# SFS Response to Submissions

(SSD9249)

Attachment 8- Methodology Statement-  
Working Near Busby's Bore

September 2018

**Figure 1:** Locational Map of known and possible Busby's Bore shafts within SFS Redevelopment Site (Source: SJB Architects with Curio Additions 2018)

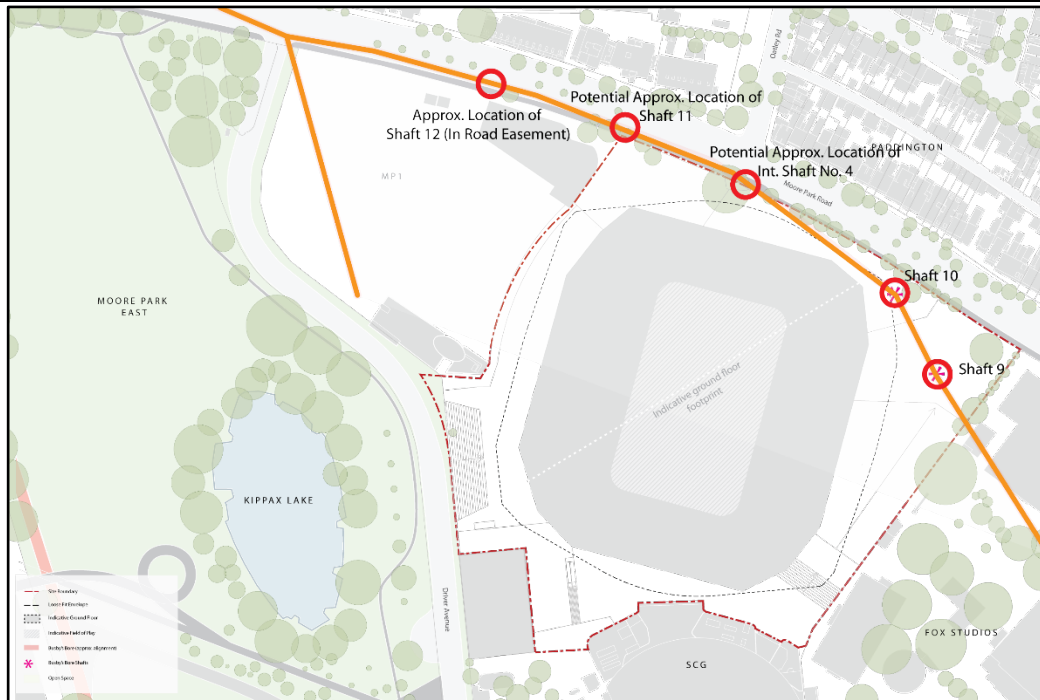
*While the proposal is for a concept building envelope, it is considered that further assessment regarding the protection of Busby's Bore during demolition and construction works would be required. The report should include a methodology of how the bore would be identified, protected, assessed and monitored throughout the demolition and construction works. The method should be included in detail in an updated Construction Management Plan, supported by the HIA. This document should be submitted for further consideration.*

*The site is affected by a State Heritage Listing and General Terms of Approval should be obtained from the Heritage Council. There is a potential that the demolition works through vibration could impact Busby's Bore.*

Prior to the commencement of demolition, investigations will be undertaken in an effort to determine the condition of the bore through the site. This will entail access through the existing shafts on site with known locations (Shafts 9 and 10). The exact path as the Bore crosses beneath the site, and the precise locations of Shafts 11 and 'Intervening Shaft 4' remain unknown.

Figure 1, below, demonstrates the location of the known shafts and an indicative path of the tunnel beneath the site, with reference to the proposed indicative footprint of the new stadium envelope.

A physical exclusion zone will be maintained around the existing shafts and the Bore (if found during investigation works). The project archaeologist and the Site Manager will liaise regarding the best location for these barriers.

Vibration monitoring devices will be installed within the shafts of Busby's Bore in a location agreed by the project archaeologist, structural engineer and acoustic consultant. A conservative vibration criterion of 3mm/s, based on structural damage criterion for 'sensitive structures' in DIN 4150 – Part 3<sup>1</sup> will be applied. The vibration monitors will be calibrated to generate real-time alerts (SMS messages and/or flashing lights) when vibration criterion is exceeded.
